## Transport Canada - Information Request Responses Gahcho Kué Project Environmental Impact Review

## GAHCHO KUÉ PROJECT ENVIRONMENTAL IMPACT STATEMENT INFORMATION REQUEST RESPONSES

Information Request Number: TC - 01 Source: Transport Canada Subject: Winter Access Road EIS Section: Section 1.3.9, Section 3.10.2.7

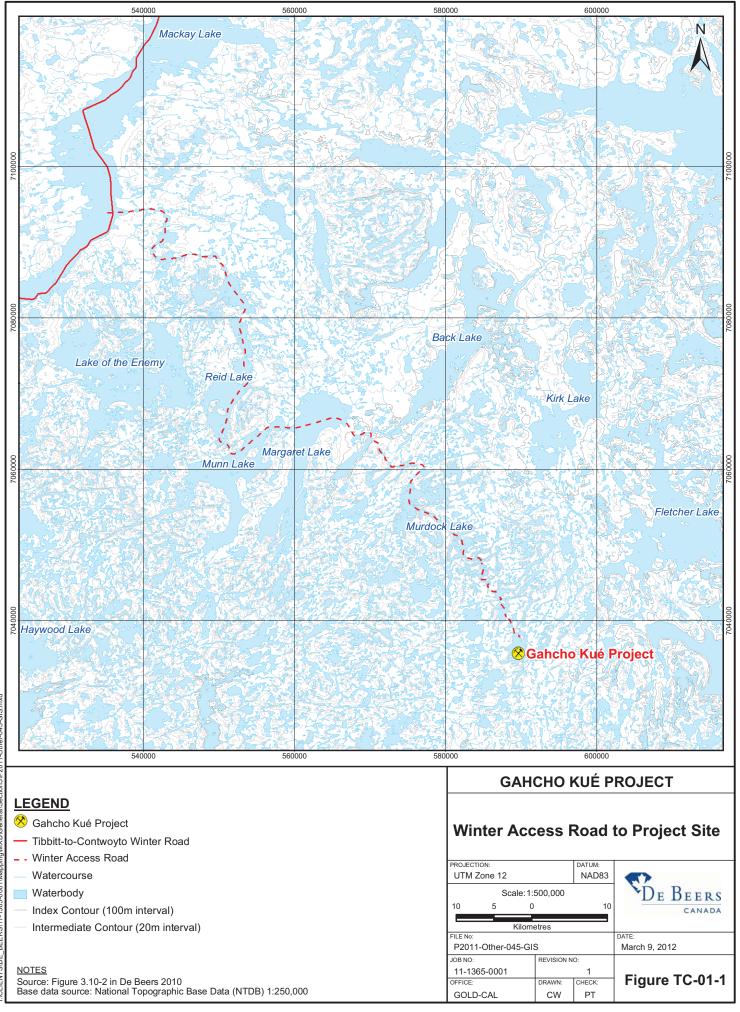
- i) Figure 3.10.2 titled "Winter Access Road to Project Site" in the EIS unclear, please provide a map at a higher resolution
- ii) Provide the details with regards to the construction, timing, and operation of the winter access roads.
- iii) If winter crossings are to be constructed across navigable waters that are frozen please provide the location of the crossings, and all materials that will be involved in the construction of the crossing(s).
- iv) If all materials will be removed before the end of the winter season.

The Gahcho Kué Project winter access road (winter access road) routing has been used several times in previous years to support exploration activities. The same routing is planned for the construction and operational phases of the mine. A higher resolution map of Figure 3.10-2 Winter Access Road to Project Site from the 2010 EIS Project Description (De Beers 2010, Section 3) is included with this response as Figure TC - 01-1.

## LAKE A3 AND OUTFLOW HYDROMETRIC STATION

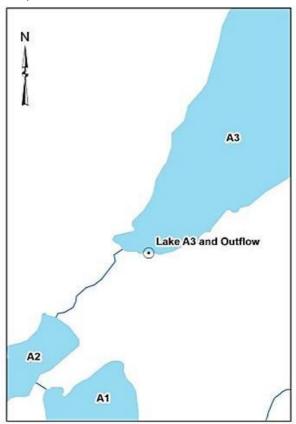
- i) A map identifying the crossing locations with the latitude/longitude coordinates.
- ii) Depth and width of the watercourse and number of culverts (if applicable) associated with those crossings.
- iii) Also please provide the erosion control measures that may be placed at these locations.

i) The only identified crossing location is on the mine access road that connects with the seasonal winter access road on the northern end of the property (refer to attached Lake A3 Fact Sheet). A watercourse crossing is designed at the Lake A3 outlet BM UTM 12 coordinates E 590742 N 7038359 (De Beers 2010, Addendum HH). The exact location and sizing of the culverts will be determined during the detailed design of the road). All mine roads will be constructed using fill only techniques and are located within the controlled area of the project development, thus drainage naturally moves to the Kennady Lake basin. Installation of small diameter culverts will be used to facilitate spring runoff water to pass through the roadbed and avoid ponding on the uphill side of the road as needed will also be sized and located during detail design.

- Lake A3 outlet stream is 0.5 m wide and 0.2 m deep measured in June 2010 (De Beers 2010, Addendum HH). Please see Lake A3 Factsheet attached. All other planned culvert locations are not considered watercourses but rather drainage patterns for spring melt runoff.
- iii) Most of the water runoff passing through the mine road network naturally drains to the water management pond. Use of silt fences at or near the culverts will be considered to capture sediments in areas where the water may flow outside the controlled area.
